**PARK CITY MUNICIPAL CORPORATION
PLANNING COMMISSION
CITY COUNCIL CHAMBERS
October 25, 2017**

PARK CITY MUNICIPAL CORPORATION
PLANNING COMMISSION MEETING MINUTES
COUNCIL CHAMBERS
MARSAC MUNICIPAL BUILDING
OCTOBER 11, 2017

1. Treasure Hill Conditional Use Permit, Creole Gulch and Town Lift Mid-station Sites – Sweeney Properties Master Plan (Application PL-08-00370)

TOWN LIFT MIDSTATION & CREOLE HEIGHT ZONES

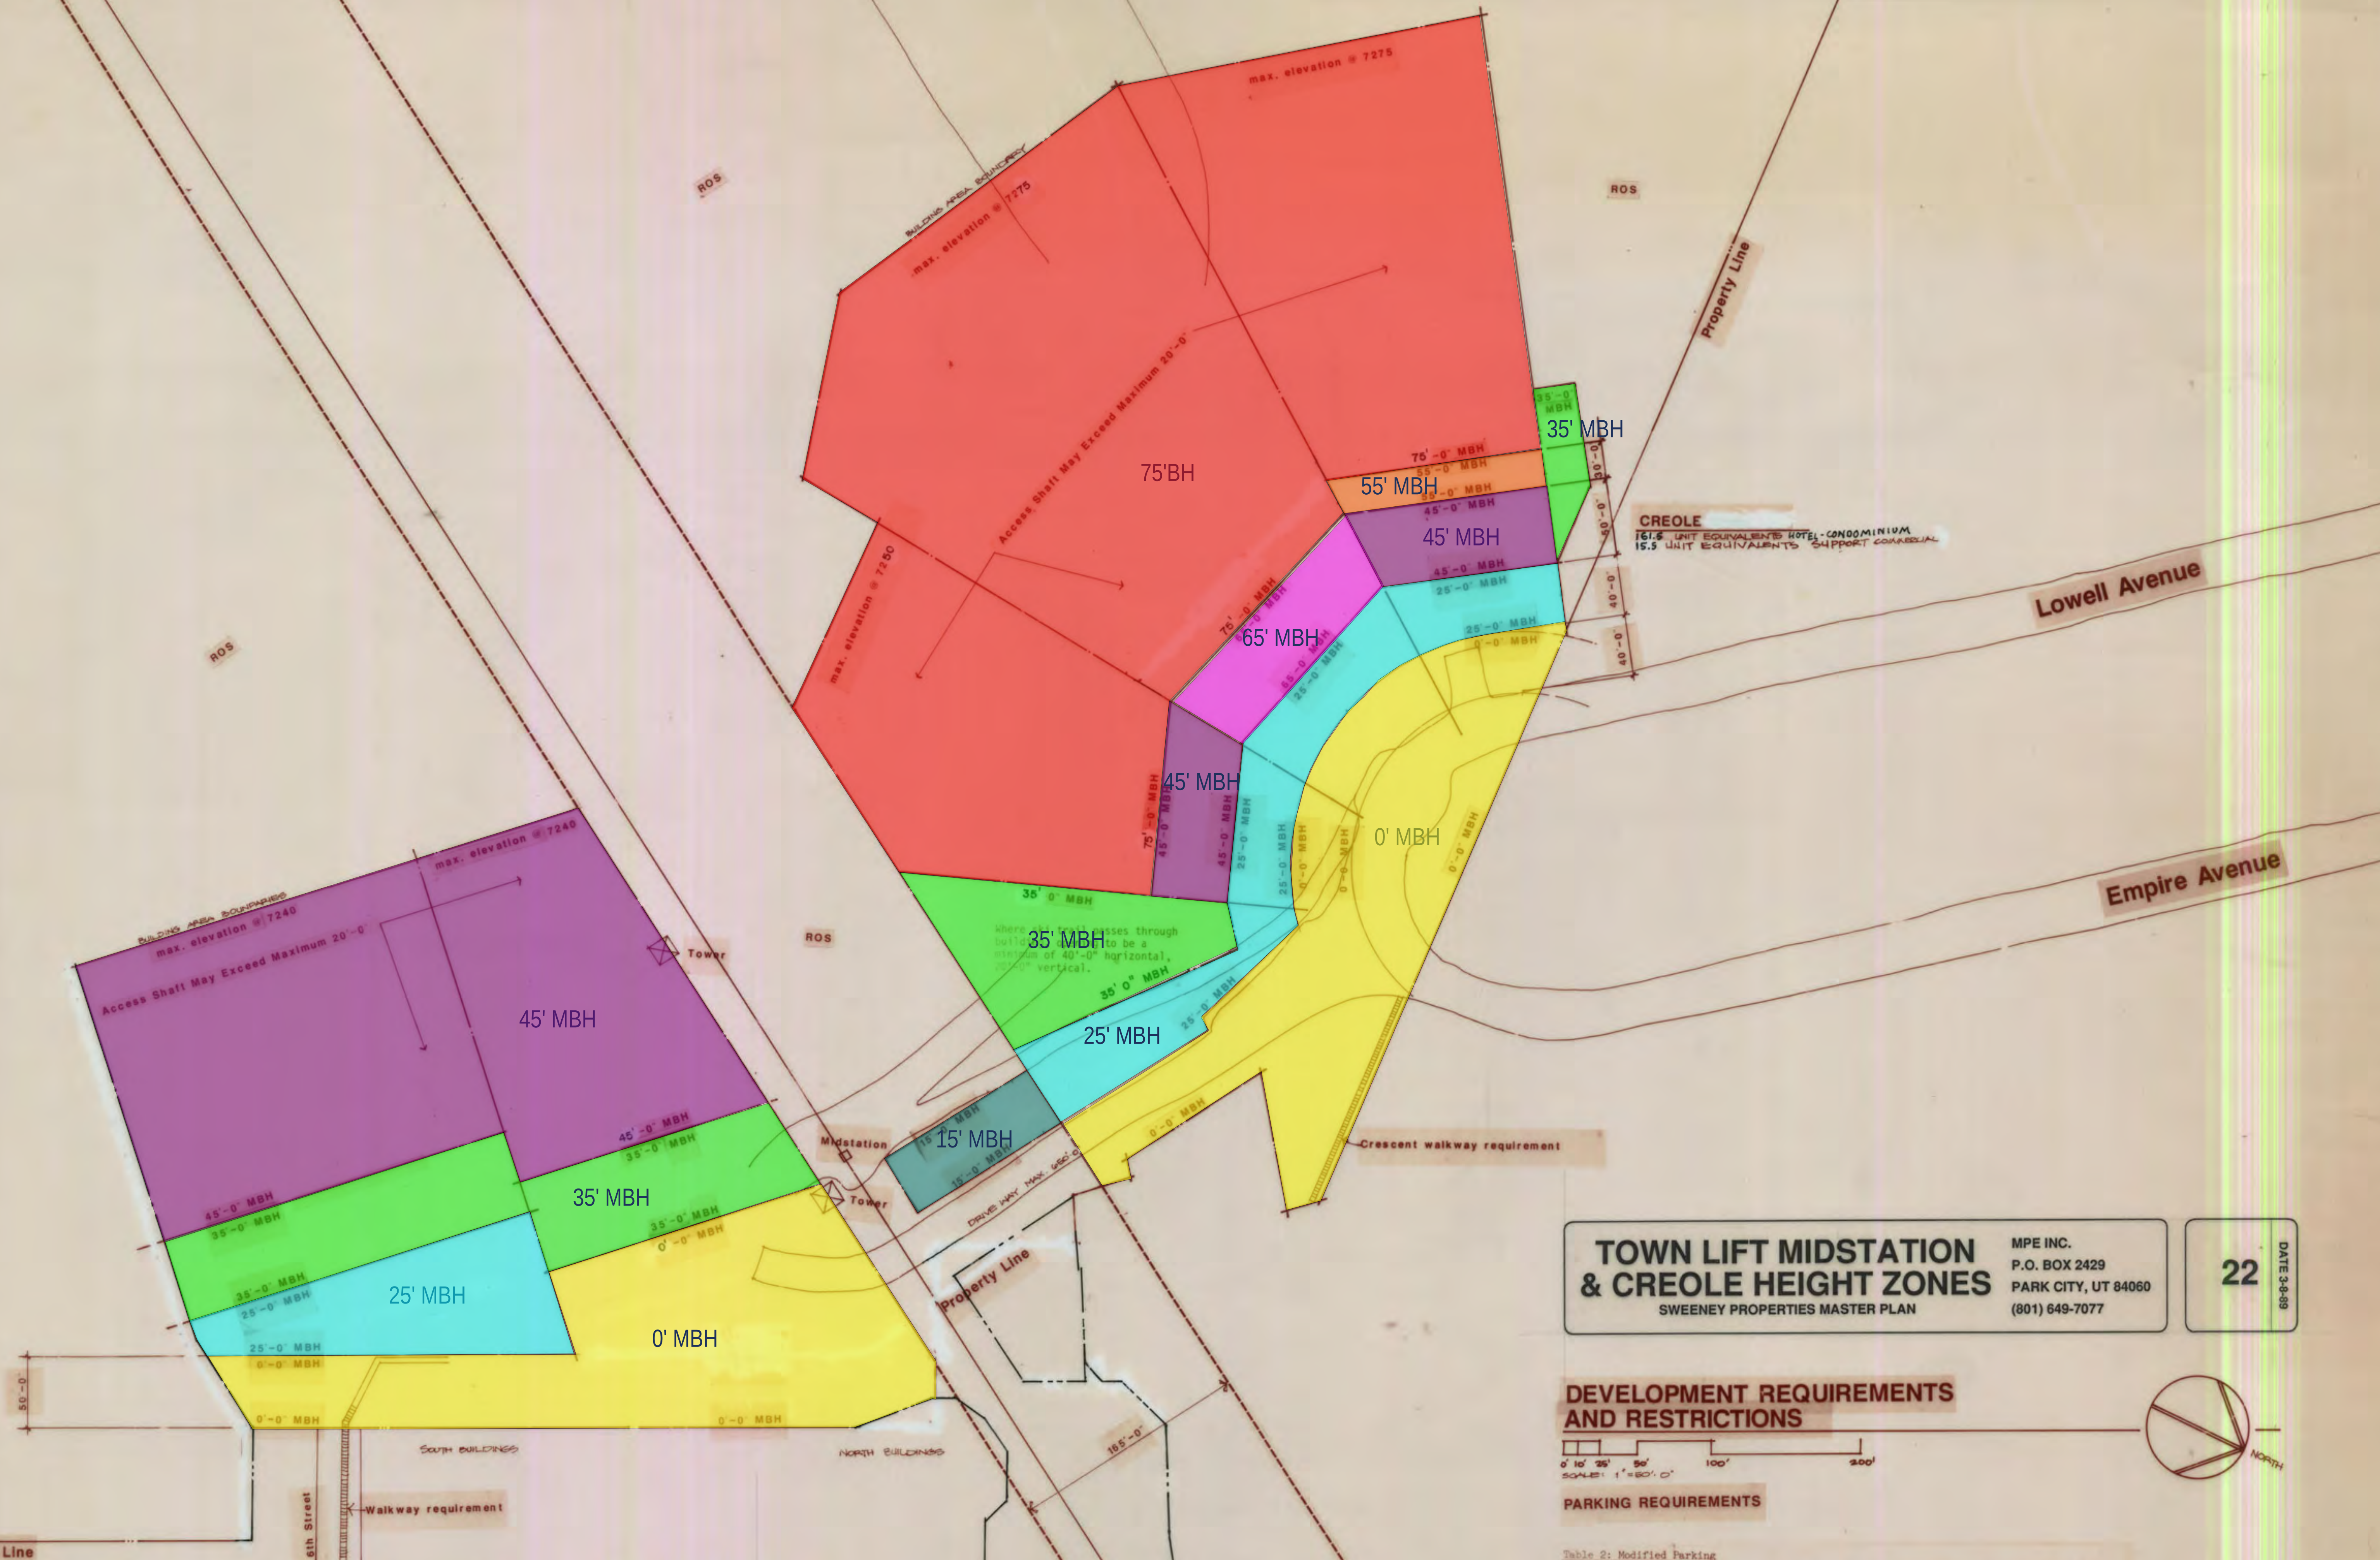
14. The parking sheets show the parking garages to be enclosed, towards the front of each building, mostly underground.
15. The Height Zone Plan sheet 22 shows the maximum building height areas/sectors with each corresponding maximum height, number of approved unit equivalents shown on each site, and Table 2: Modified Parking Standard, also Building Area Boundaries.

ELEVATION BUILDING D AND SITE SECTION

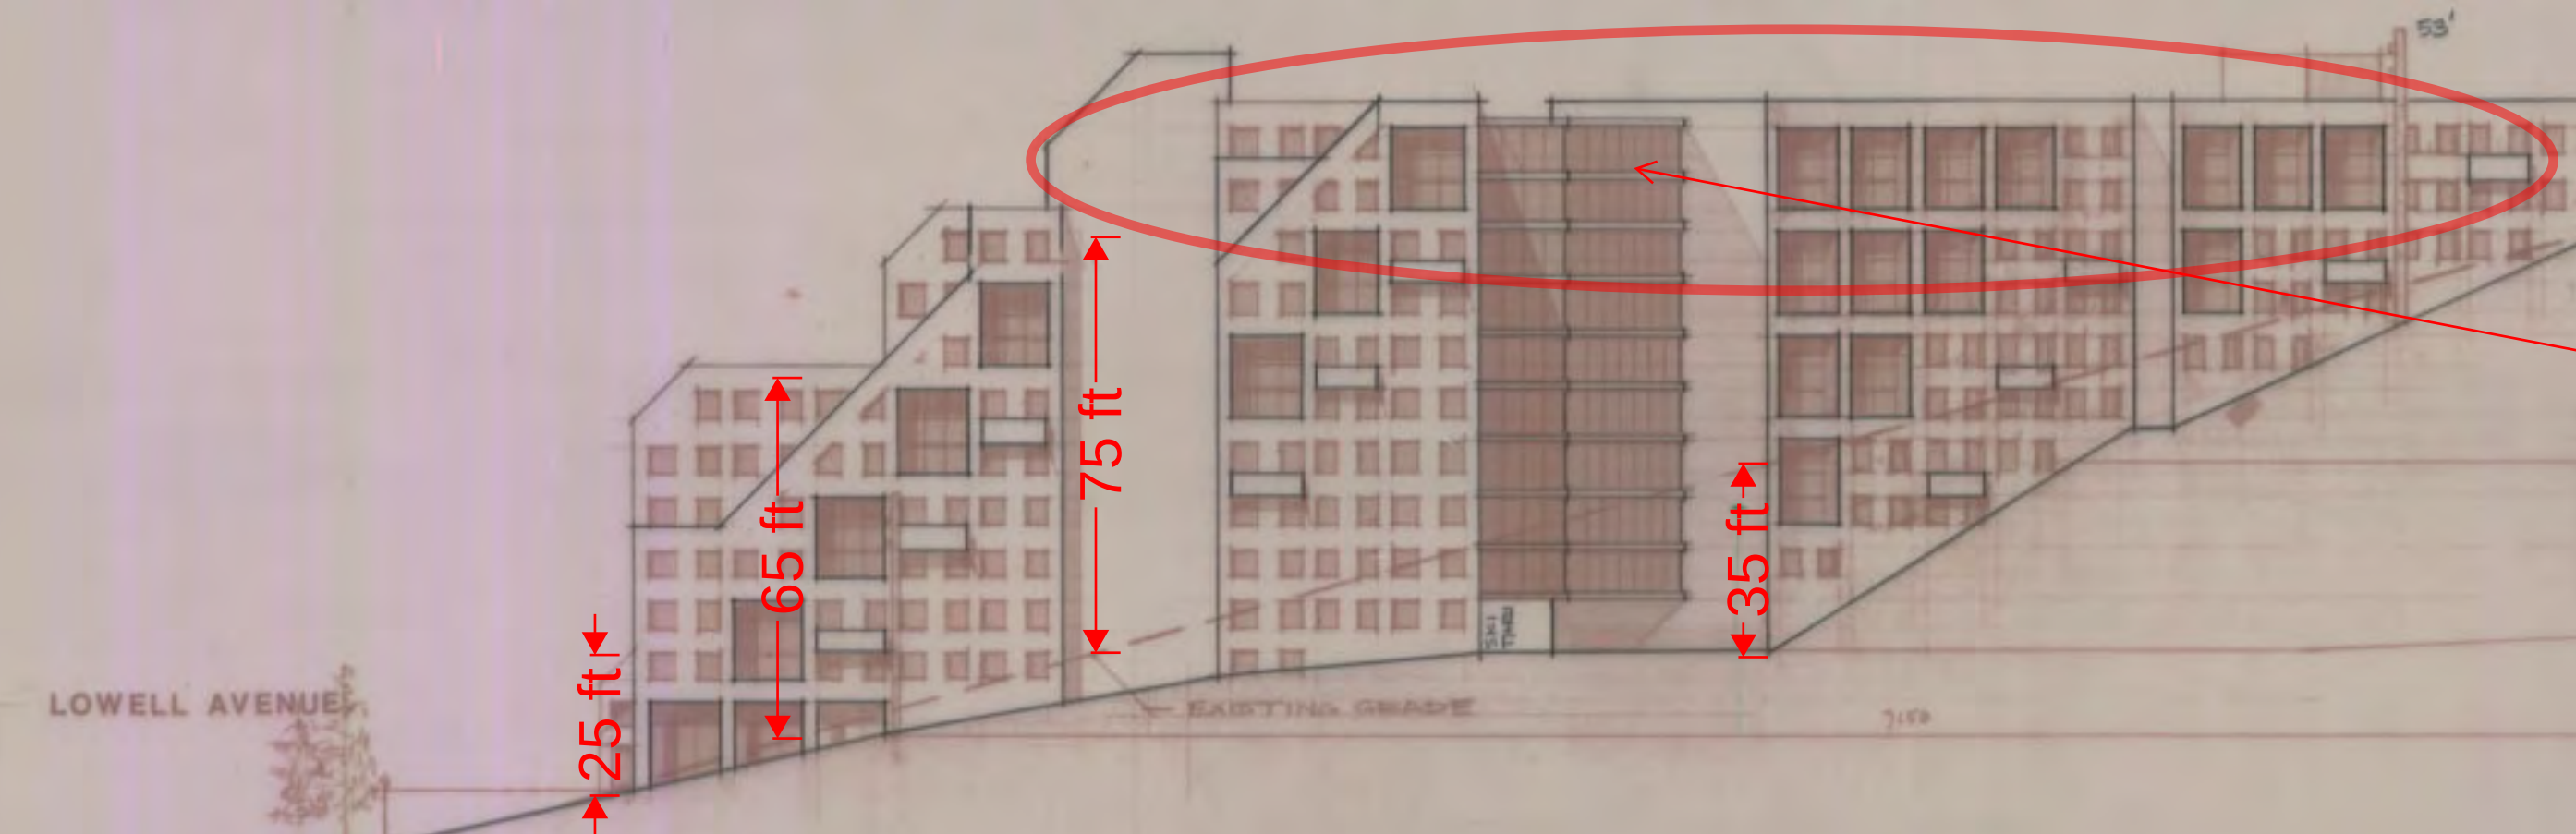
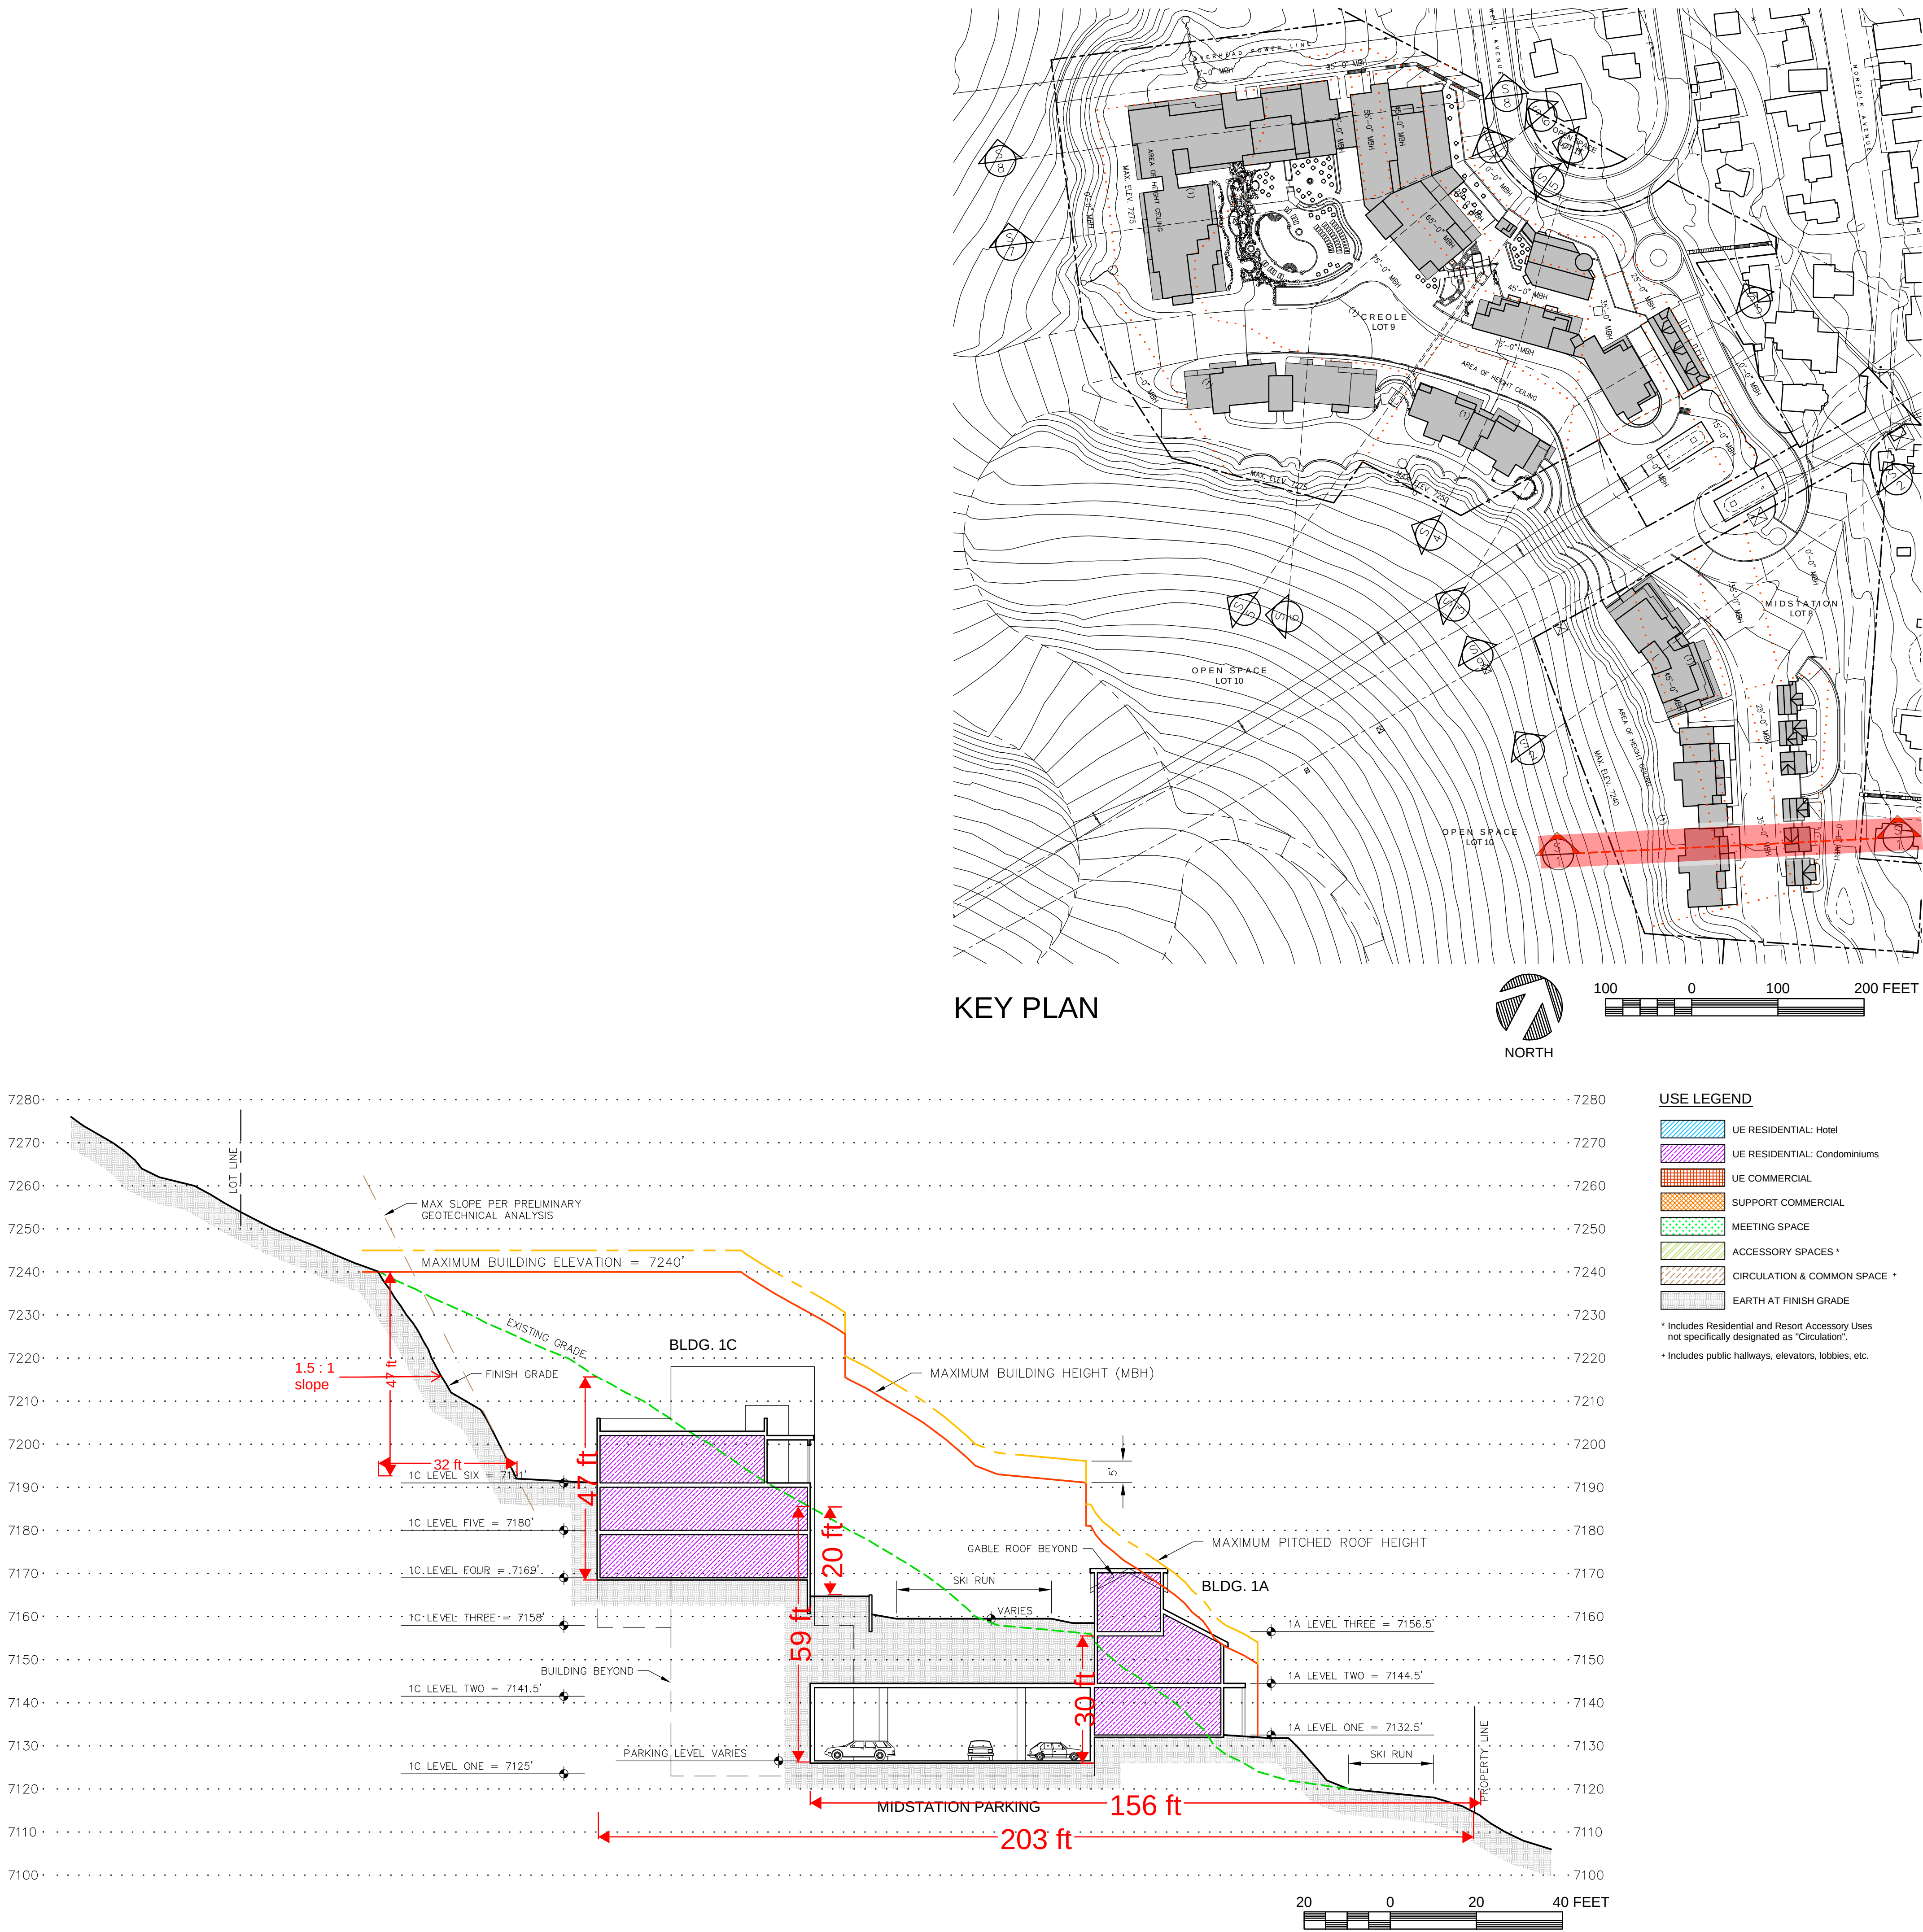
27. Sample elevation C and E show compliance with the building sections/height zone plan, measured from existing grade. Sample elevation D was not updated/amended to show the adopted height as the change is indeed reflected on the building section sheet 17 and height zone plan sheet 22.
28. Sheet 28 and 29 show each ski run bi-furcating its corresponding site as well as the development boundaries.

TOP OF BUILDING NOT UPDATED TO REFLECT APPROPRIATE HEIGHT AS CHANGED & SHOWN ON BLDG. SECTION D ON SHEET 18 OR REFLECTED ON HEIGHT ZONES SHEET 22
